25315 - BESD TREMONTON ELEMENTARY
2900 West 500 North Tremonton, UT

Addendum **ADD-003.0**

ADDENDUM 003

A600

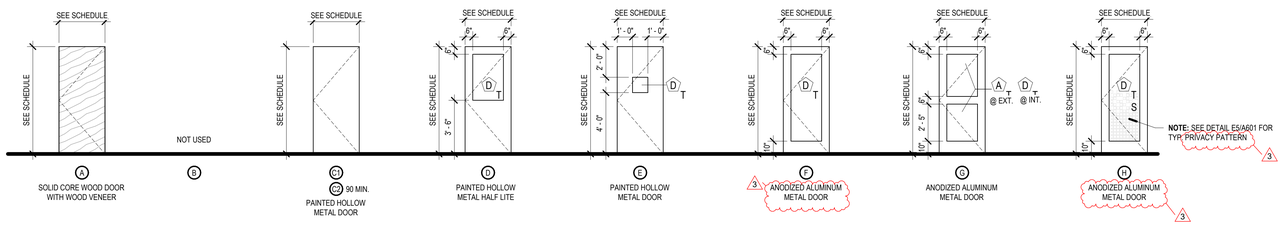
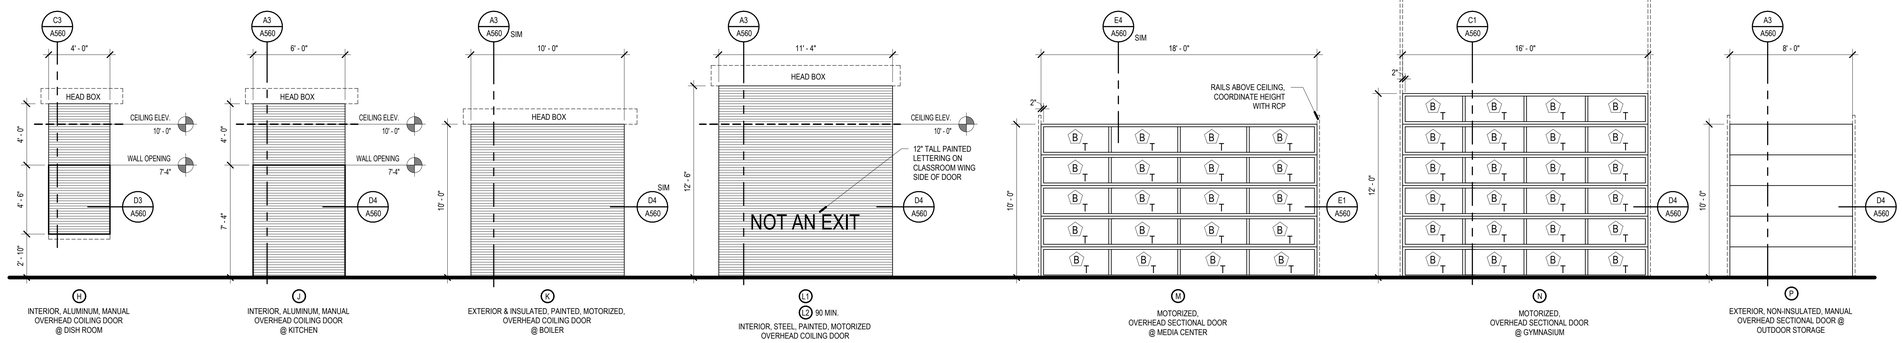
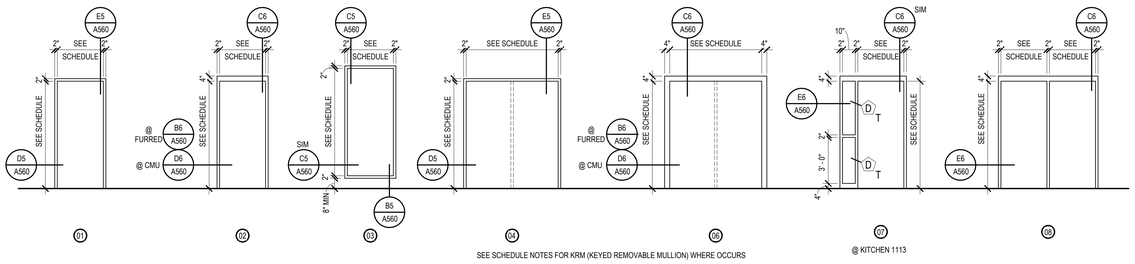
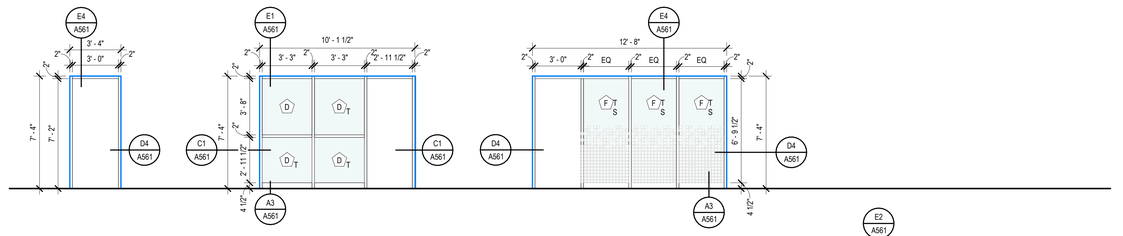
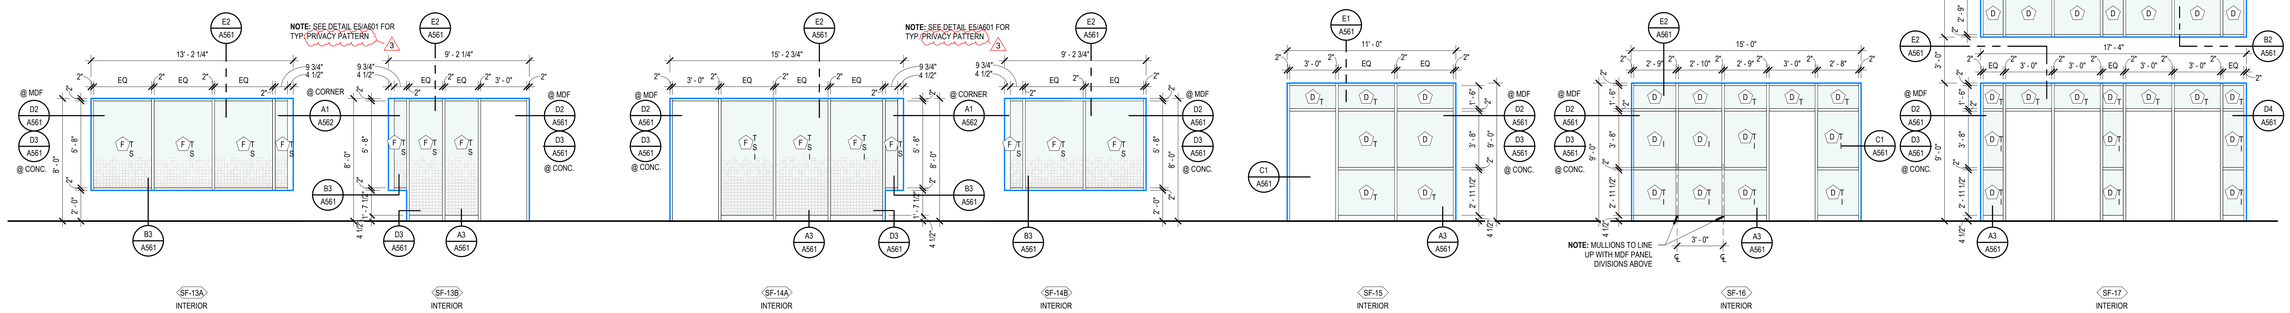
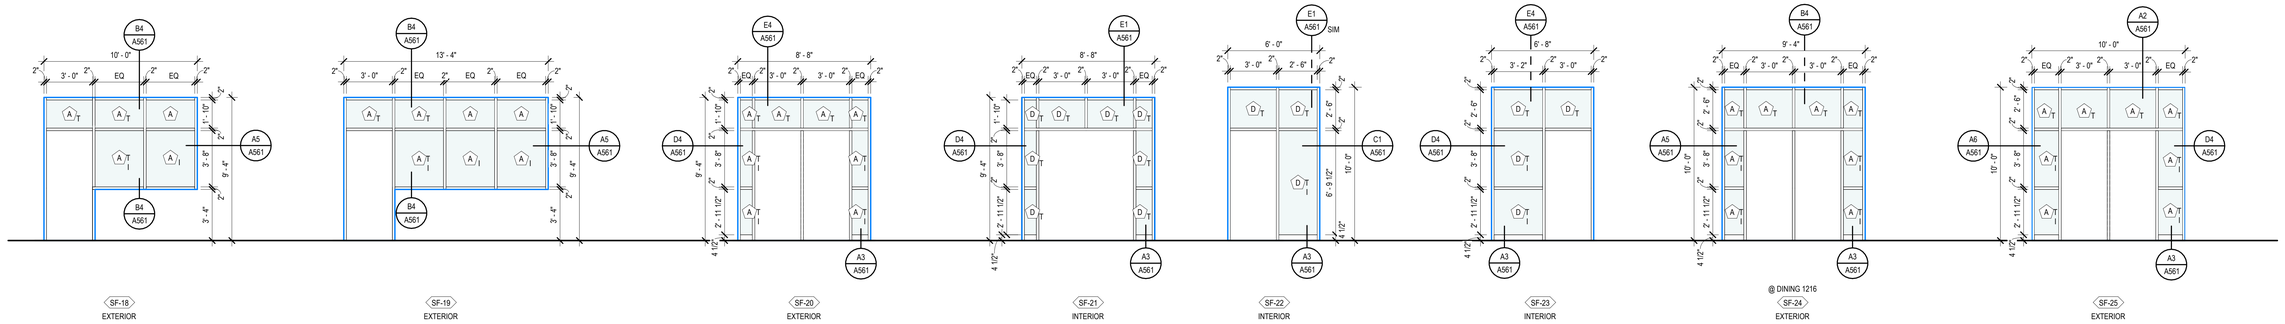
- Sheet A505 - Detail A4 – Removed sand from detail & modified concrete slab text.
- Sheet A600 – Updated door types, per attached sheet
- Sheet A601 – Clarified notes about privacy patterning. Changed all aluminum door types to be anodized, not painted.
